IAE Propulsion System - Nacelle **SERVICE BULLETIN**

Subject: Transmittal of Revision 1 to Service Bulletin Number V2500-NAC-36-0006

NACELLE - POWERPLANT - TUBES, PRESSURE INDICATING -
TUBE CLIPS - REPLACEMENT OF:

V2500-NAC-36-0006

REPLACEMENT OF SENSE TUBE 'P' CLIPS
FIGURE 3 SHEET 3

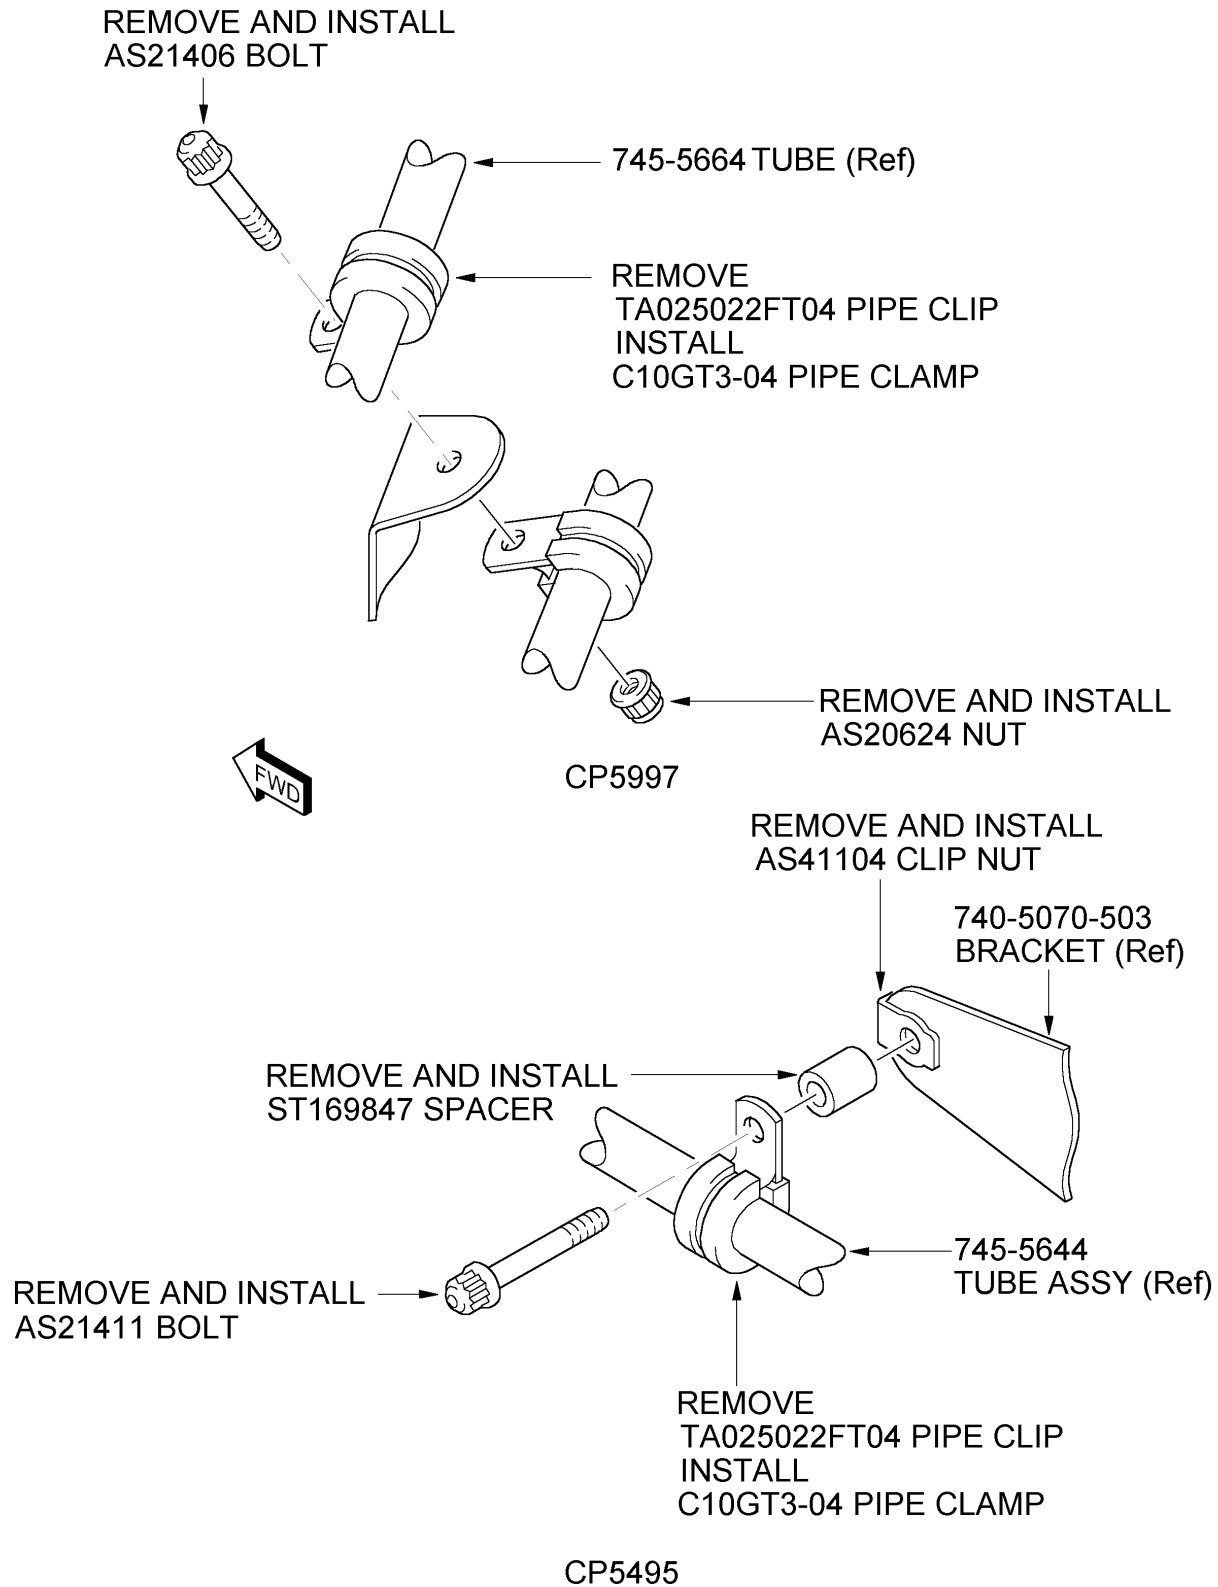
- (5) Remove the TAO25022FT04 'P' clip, AS21408 bolt and AS41104 clip nut from clipping point CP5433. Discard the 'P' clip. (Refer to Figure 3 sheet 3).

- (6) Install new C10GT3-04 'P' clamp and secure with the bolt and clip nut removed in previous step.
- (7) Remove the TAO25022FT04 'P' clip, AS21406 bolt and AS41104 clip nut from 740-5464-501 bracket at clipping point CP5996. Discard the 'P' clip. (Refer to Figure 3 sheet 3).

- (8) Install new C10GT3-04 'P' clamp and secure with the bolt and clip nut removed in previous step.
- (9) Remove the TAO25022FT04 'P' clip, AS21408 bolt, AS20426 nut and SP154-D washer from 740-5070-503 bracket at clipping point CP5865. Discard the 'P' clip.

REPLACEMENT OF SENSE TUBE 'P' CLIPS
FIGURE 3 SHEET 4

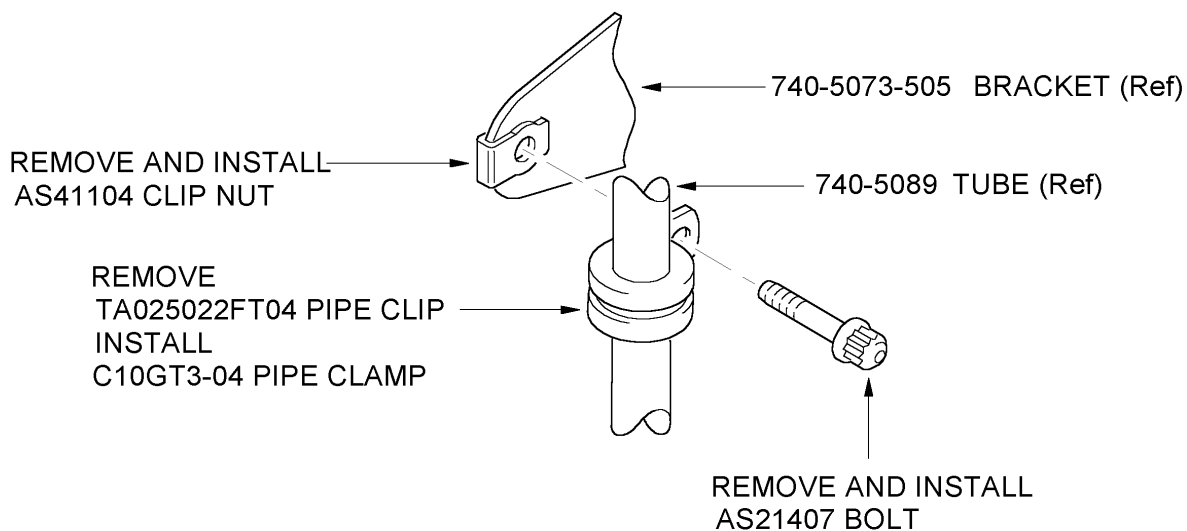
- (10) Install new C10GT3-04 'P' clamp and secure with the bolt, nut and washer removed in previous step.
- (11) Remove the TAO25022FT04 'P' clip, AS21406 bolt and AS41104 clip nut from the bracket at clipping point CP5997. Discard the 'P' clip. (Refer to Figure 3 sheet 4).

- (12) Install new C10GT3-04 'P' clamp and secure with the bolt and clip nut removed in previous step.
- (13) Remove the TAO25022FT04 'P' clip, AS21411 bolt, AS41104 clip nut, and ST1698D-47 spacer from 740-5070-503 bracket at clipping point CP5495. Discard the 'P' clip.

REPLACEMENT OF SENSE TUBE 'P' CLIPS
FIGURE 3 SHEET 5

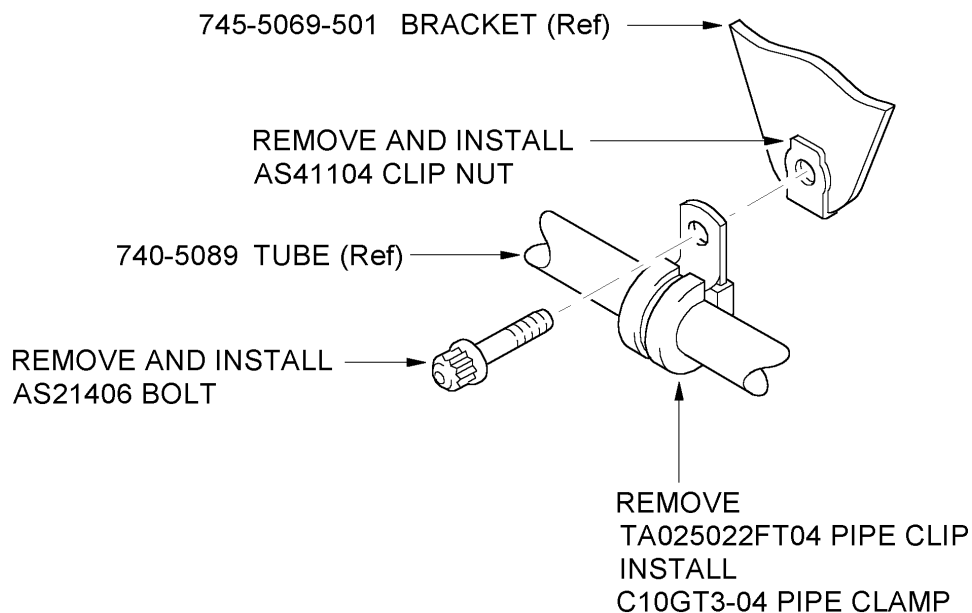
- (14) Install new C10GT3-04 'P' clamp and secure with the bolt, clip nut and washer removed in previous step.
- (15) Remove the TAO25022FT04 'P' clip, AS21407 bolt and AS41104 clip nut from 740-5073-505 bracket at clipping point CP5862. Discard the 'P' clip. (Refer to Figure 3 sheet 5).

- (17) Remove the TAO25022FT04 'P' clip, AS21406 bolt and AS41104 clip nut from 740-5069-501 bracket at clipping point CP5931. Discard the 'P' clip.
- (18) Install new C10GT3-04 'P' clamp and secure with the bolt and clip nut removed in previous step.
- (19) Torque all the bolts to 40 lbf in (4.52 Nm).

- (16) Install new C10GT3-04 'P' clamp and secure with the bolt and clip nut removed in previous step.
